Submission to: Planning Services, Department of Planning and Environment. GPO Box 39, Sydney, NSW,2001

Application Number: SSI 7485

Application Name: WestConnex M4-M5 Link

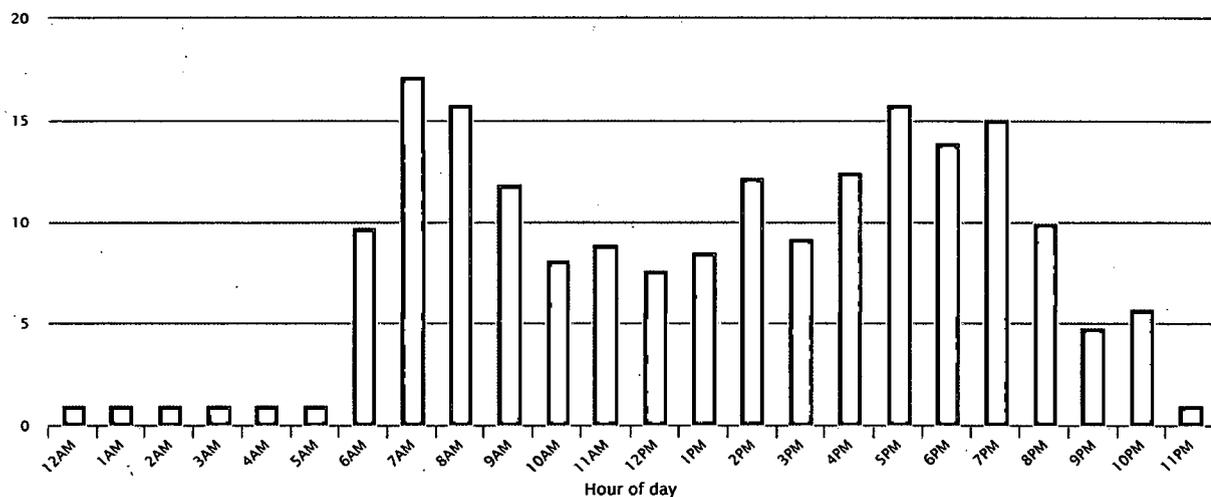
- I object to the EIS because the proponent has failed to take account of the cumulative impact of its proposed Darley Road, Leichhardt civil and tunnel site operations and the aircraft noise which the residents near the site already endure.

The attached extract from Webtrak shows that Darley Road, Leichhardt and adjacent streets are directly under the flight path.

Airservices Australia reports that in April to June 2017 the number of average daily noise events over 70 dBA. In Leichhardt this is an average of 16- 17 per hour over the peak morning period and 16 per hour in the early evening peak period.

Figure 6-4 Project footprint - Map 2

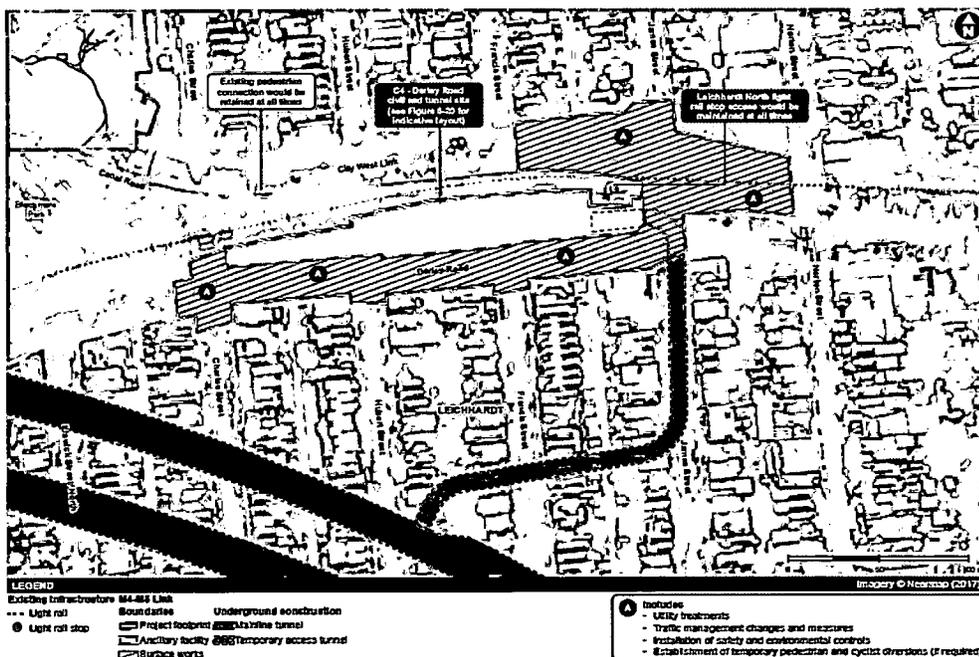
- I object to the EIS because it does not guarantee that the existing access to the Leichhardt North light rail stop would be maintained at all times. Fig 6-4 indicates that only the eastern access will be maintained. This greatly disadvantages the elderly and disabled who have to walk up a steep hill to the eastern access. If the proponent cannot guarantee access to the Leichhardt North light rail stop from the existing entry points or from points that are accessible to all then the Darley Road, Leichhardt construction site should be abandoned. The proponent should be directed to find a site where its operations will not impact on users of the Light Rail.
